Access Compliance Report Public Rights-of-Way (Curb Ramps)

Main Street: COUNTRY_LN **Cross Street:** SE_SKYLINE_DR **Location:** E

ADA ID: RPRK211012115048 **Ramp Type:** Type 6 - Directional 1 **Initial Pass/Fail:** Pass **Overall Compliance:** No **Severity Score:** 15

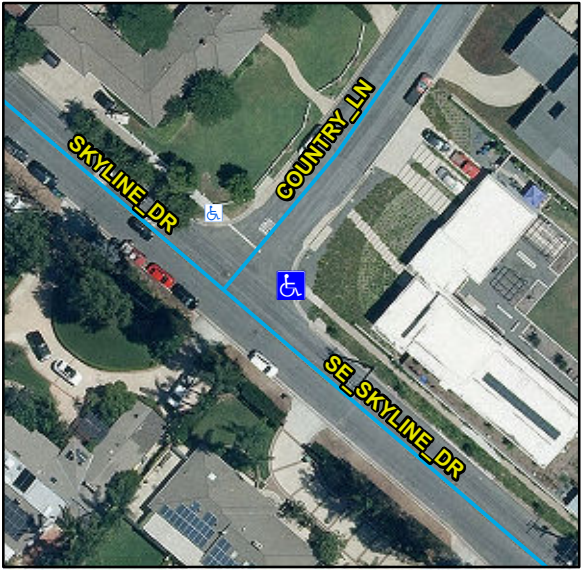
Compliance	Description	Data	Compliance	Description	Data
N/A	Ramp Length (in)	128	Yes	Flare Type LT	
Yes	Ramp Width (in)	97			Curbed2
Yes	Ramp Run Slope (%)	6.4	N/A	Flare Slope LT (%)	N/A
Yes	Ramp Cross Slope (%)	0.2	N/A	Flare Traversable LT	N/A
No	Grade Break	No	N/A	Flare Type RT	
N/A	Grade Break Slope (%)	N/A			Sloped
N/A	Grade Break Cross Slope (%)	N/A	N/A	Flare Slope RT (%)	7.2
	Addl Para Ramp Left?	No	N/A	Flare Traversable RT	No
	Addl Para Ramp Right?	No	No	DWS Provided	No
N/A	Landing Present	Yes	N/A	DWS Contrast	N/A
Yes	Landing Length (in)	110	N/A	DWS Length (in)	N/A
Yes	Landing Width (in)	48	N/A	DWS Full Width	N/A
Yes	Landing Run Slope (%)	0.5		DWS Offset Type	N/A
Yes	Landing Cross Slope (%)	0.9	N/A	DWS Left Offset (in)	N/A
N/A	Landing Movement Obstructed?	No	N/A	DWS Right Offset (in)	N/A
	Landing Movement Type	N/A			
N/A	Landing Shared	No			
N/A	Marked Crosswalk 1	No	N/A	Clear Space	N/A
	Crossing 1 Direction	NW	N/A	Clear Space To Crosswalk (in)	N/A

Marked Crosswalk 1 Width (in)	N/A			
N/A	Ramp Inside Crosswalk 1	N/A			
	Crossing 1 Slope (%)	1.2			
	Crossing 1 Cross Slope (%)	1.6			
Yes	Gutter Ponding	No	Yes	Curb Slope	5.4
Yes	Gutter Lip Height (in)	0		Road Run Slope (%)	N/A
No	Gutter Run Slope (%)	6.2		Road Cross Slope (%)	N/A
Yes	Gutter Cross Slope (%)	1.4		Parallel Ramp Side	Right
Yes	Overall Surface Condition	Acceptable	Yes	Perp Joint Present	Yes
	Cross Gutter Present?	No		Spandrel Present?	No
	Replace Cross Gutter?	N/A		Replace Spandrel?	N/A

Possible Solutions:
Remove & Replace Entire Ramp. Remove & Replace Gutter.
